The ADA Checklist for Existing Facilities

Priority 3 - Toilet Rooms

Building Estherville Public Library

Date December, 2023

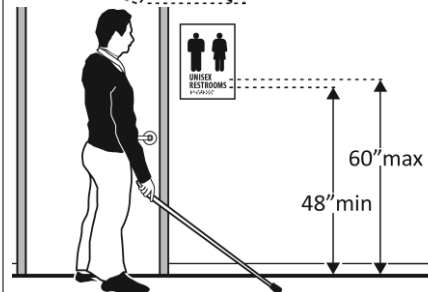
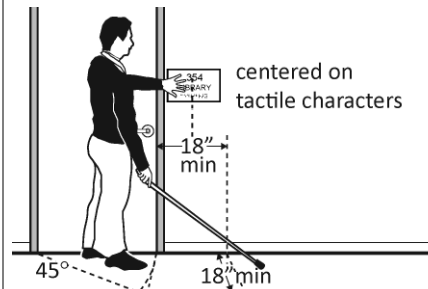
With clear floor space beyond the arc of the door swing and 45-degree open position, at least 18 x 18 inches centered on the tactile characters? *
[703.4.2]

Measurement:
3' + in both directions

So the baseline of the lowest character is at least 48 inches above the floor and the baseline of the highest character is no more than 60

Measurement:
57-58"

Sign is mounted on the hinge side of the door.

- Install tactile sign
- Relocate sign
- Consider moving the sign

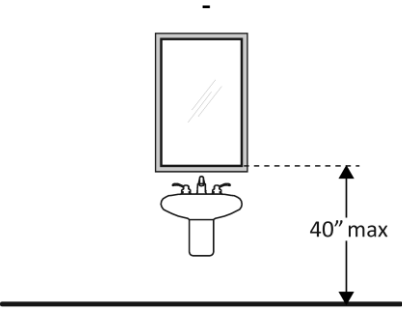
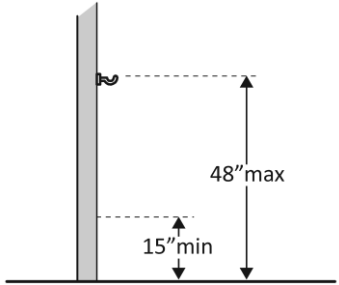
<p>3.6 Is the door opening width at least 32 inches clear, between the face of the door and the stop, when the door is open 90 degrees? [404.2.3]</p>	<p><input checked="" type="checkbox"/> Yes <input type="checkbox"/> No</p> <p>Measurement: 33" outer door 34" stall door</p>		<p>Photo #:</p>	<ul style="list-style-type: none"> • Install offset hinges • Alter the doorway •
--	--	--	-----------------	---

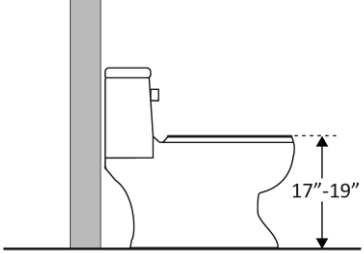
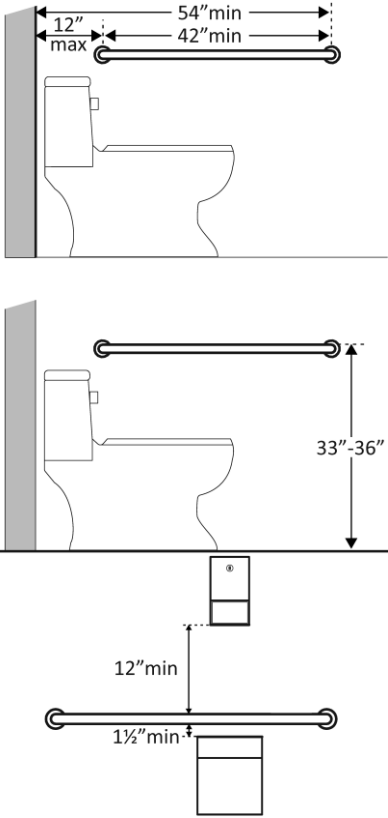
<p>3.20 If there is a coat hook, is it no less than 15 inches and no greater than 48 inches above the floor?*</p>	<p><input type="checkbox"/> Yes <input checked="" type="checkbox"/> No</p> <p>Measurement: 54"</p>		<p>Consider adding a lower coat hook</p> <p>Photo #:</p>	<ul style="list-style-type: none"> • Adjust hook • Replace with or provide additional accessible hook • <p>* If installed before 3/15/2010 and the clear floor space allows a parallel approach, the coat hook may be 54 inches above the floor.</p>

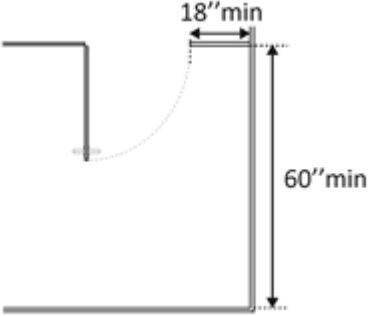
<p>3.31 Is clearance provided around the water closet measuring at least 60 inches from the side wall and at least 56 inches from the rear wall?*</p> <p>[604.3.1]</p>	<p><input checked="" type="checkbox"/> Yes <input checked="" type="checkbox"/> No</p> <p>Measurement: 57"x59"</p> <p>very close!</p>	 <p>The diagram illustrates a top-down view of a toilet fixture. A dashed line indicates a 56-inch minimum clearance from the rear wall to the centerline of the toilet. Another dashed line indicates a 60-inch minimum clearance from the side wall to the centerline of the toilet.</p>	<p>Overall the dimensions work, but we are 1" shy one direction and 1" over the other direction.</p> <p>Photo #:</p>	<p>* If constructed before 3/15/12, clearances around water closets in single user toilet rooms can be 48 inches wide by 66 inches long or 48 inches wide by 56 inches long (depending on the approach to the water closet, see 1991 Standards Figure 28) and the lavatory may overlap that clearance if the door to the room does not swing into the required clearances at fixtures (such as lavatories, water closet and urinals) and the edge of the lavatory is at least 18 inches from the centerline of the water closet</p> <ul style="list-style-type: none"> • Alter room/compartments for clearance • •
